Dewberry Response to USGS Review of the Virginia FEMA NRCS South Central LiDAR Project– Blocks 1 and 2 Corrections

Produced for U.S. Geological Survey

USGS Contract: G16PC00020
Task Order: G17PD01206
Report Date: 09/25/2019

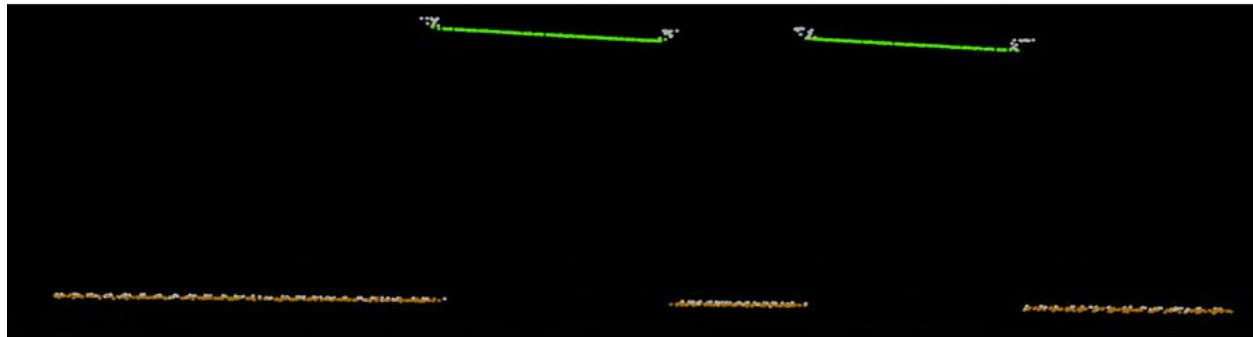
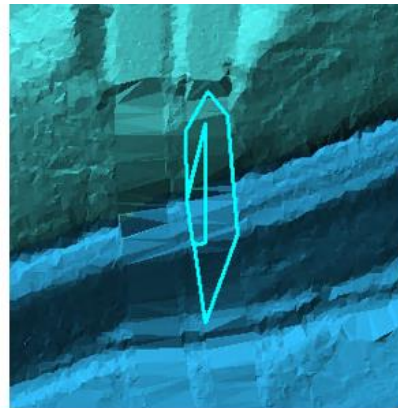
Remove wedge (1)	Commented in report as partially left unchanged. This call is identified in the provided shapefile.	Dewberry showed this call and data during the July 18 webinar. Dewberry cannot identify any high points causing a wedge at this location. Please see Figure 4 below. Dewberry has reviewed the DEM and the lidar point cloud; no issues could be identified.
Remove wall to water level (4)	Commented in report as left unchanged and accepted by NGTOC management but reviewer does not agree. One (1) of these are identified in the provided shapefile.	When acting as an impoundment, Dewberry classifies the main dam structure to ground (elevated portions of the dam feature such as building-like structures on top of the main dam feature are classed as unclassified) as it is retaining the water, just as a rock wall or other permanent feature would do. While man-made (but so are culverts, expressway ramps leading to bridges, retaining walls, and other features which remain classified to ground), it is a restricting or holding barrier for the water, which can be very important for modeling purposes. Dams are constructed at varying heights and water levels within dam impoundments can vary so the height of the dam structure above the water surface can be variable. Because the dam structure on the water side is often vertical,

Replace ground points on road and under bridge (1)	This feature is identified in the provided shapefile.	Dewberry showed this call and data during the July 18 webinar. Dewberry cannot identify any additional points below the bridge which could be reclassified to ground at this location. Please see Figure 4 below. Dewberry has reviewed the DEM and the lidar point cloud; no issues could be identified.
DEM Coordinate Reference System (CRS) is in two formats	Commented in report as 5021 DEM CRS do not have the Datum described as: DATUM ["NAD83_National_spatial_Reference_System_2011"] and that the DEMs delivered are in two different formats.	Dewberry has verified that all DEMs consistently state the horizontal datum as [D_NAD_1983_2011]. Dewberry has started to implement custom CRS files for DEMs delivered to USGS LBS v1.3 projects, but we have not done this for any other USGS LBS v1.2 project. As this is an easy implementation, Dewberry has performed this update for these deliverables, including all DEMs for blocks 1 and 2.

Figure 4-USGS made a call to remove a wedge and add additional points to ground below the bridge. Dewberry could not identify any wedge in the data or additional points to reclassify to ground so no changes were made at this location. Dewberry did make modifications in another portion of a tile which intersects these calls so one of these tiles was re-delivered. After reviewing the corrections, USGS made a call that a partial wedge remains but Dewberry did not make any modifications to this location. The top left image shows the call overlaid on Esri base imagery. The top right image shows the call overlaid on a terrain created from ground points. The bottom image shows a profile of this location in the point cloud (class 1-gray, class 2-orange, class 17-green). Dewberry could not identify any high ground points which would be creating a wedge nor did Dewberry identify any additional points which could be reclassified to ground.

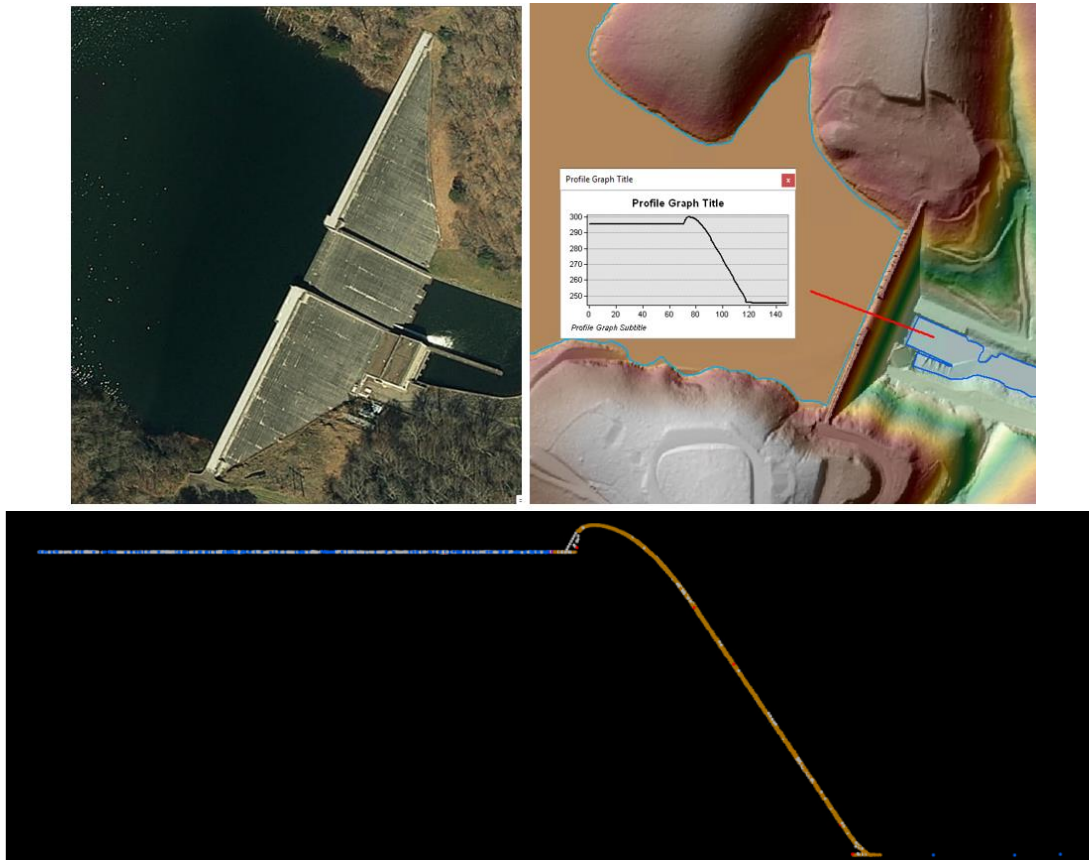
Remove dam structures located high above the water level (4)	Marked as "red" in the initial report overview, DEM section overview, and screenshot example section. No edit calls for this type of call are located within the provided shapefile.	Please see comment for "Remove wall to water level" USGS calls in the block 1 DEM calls table above and Figures 5 and 6 below.

Figure 5- When acting as an impoundment, Dewberry classifies the dam structure to ground as it is retaining the water, just as a rock wall or other permanent feature would do. Dams are constructed at varying heights and water levels within dam impoundments can vary so the height of the dam structure above the water surface can be variable. Because the dam structure on the water side is often vertical, lidar may only capture the top of the dam structure and not the side of the dam structure. This approach has been confirmed multiple times by USGS. The top left image shows the dam in Esri base imagery. The top right image shows the DAM in the bare earth DEMs along with the location of a profile in red. The bottom image shows the profile location in the lidar point cloud (class 1- grey, class 2-orange, class 7-red, class 9-blue, class 10-purple).

Figure 7-USGS identified a monotonicity discrepancy of only ~ 2 cm. Dewberry has re-flattened this section of river.

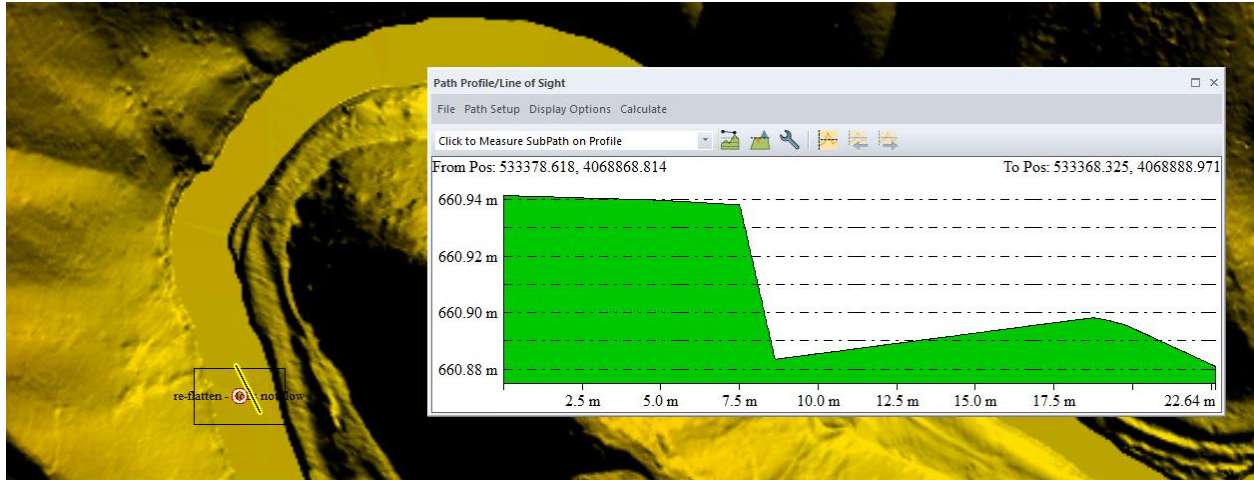
Spikes (2)	Two (2) new spikes created by contractor	Dewberry corrected the newly identified spikes and re-delivered the affected tiles to USGS with this document.
Re-flatten (1)	This feature is identified in the provided shapefile.	This edit call identifies a 2 cm monotonicity discrepancy-please see Figure 7. While Dewberry feels the 2 cm difference is well within tolerances for QL2 lidar projects with a 1 meter DEM cell size requirement, Dewberry has re-flattened this small section of river and re-delivered the affected tile to USGS with this document.
